GOURDIE-FRASER
123 West Front Street
Traverse City, Michigan 49684

ADDENDUM #1

| <u>PROJECT</u> | <u>BIDS DUE</u> |
|---|---|
| 2017 Water Main Replacement for the Village of Central Lake | Date: March 29, 2017 Time: 11:00 am Location: Village of Central Lake |

GFA Project No: 16374

**VILLAGE OF CENTRAL LAKE
 2107 WATER MAIN REPLACEMENT
 PLAN AND PROFILE SHEET
 SECTIONS 22, 23, & 27, T.31 N., R.8 W.
 VILLAGE OF CENTRAL LAKE, ANTRIM COUNTY, MICHIGAN**

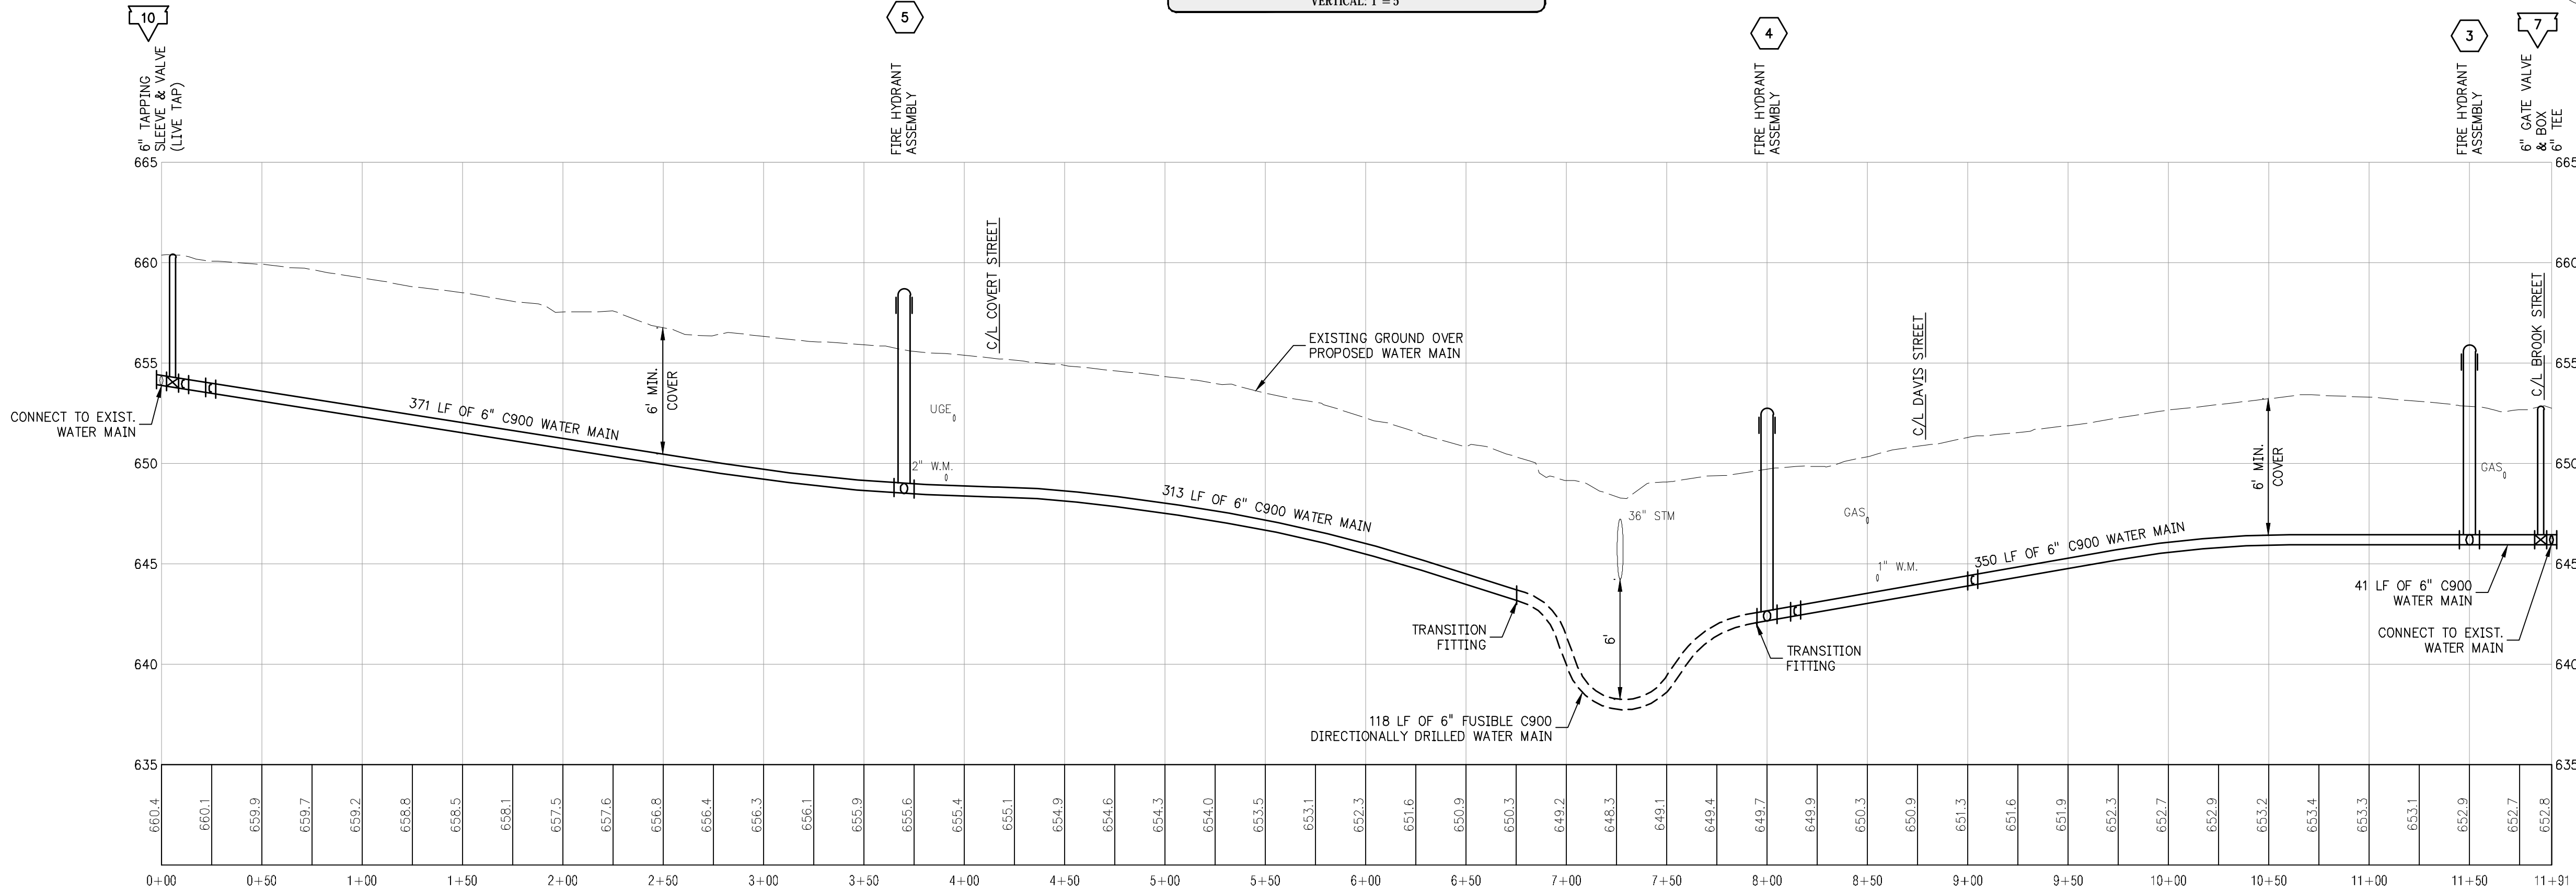
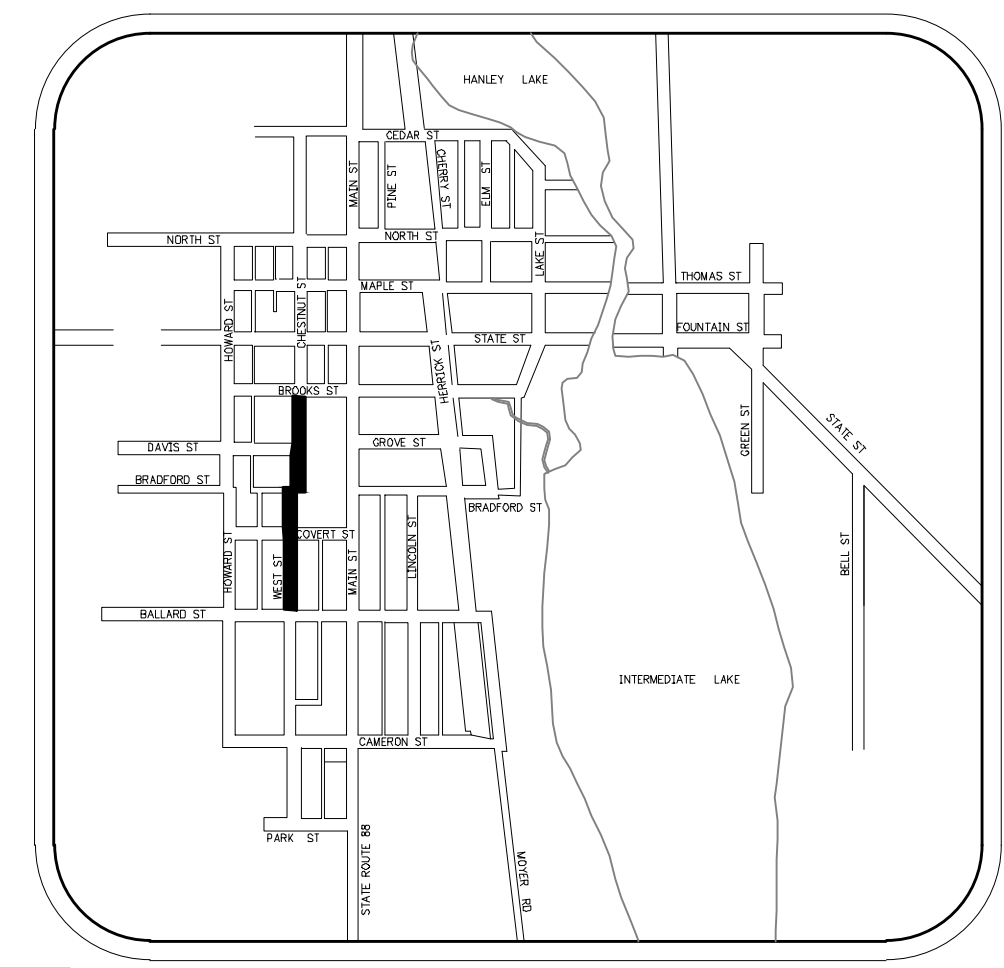
3. Sheet C2.3 has been updated to eliminate the proposed new 6" main to the existing 2" main in two locations at Covert Street via 2" tapping sleeve & valve. Contractor shall install utilizing a 2 inch tap and saddle with a 2 inch curb stop and box comparable to a the installation of a service lead as a conventional tapping sleeve and valve is not available for that size. The system must remain online and operational, service disruption must be prevented. Refer to the standard lead connection detail on Sheet 3.1 and Specification 9.02.G for additional information. Sheet C2.3 shall be stricken in its' entirety from the bid package and replaced with the revised sheet including with this addendum.
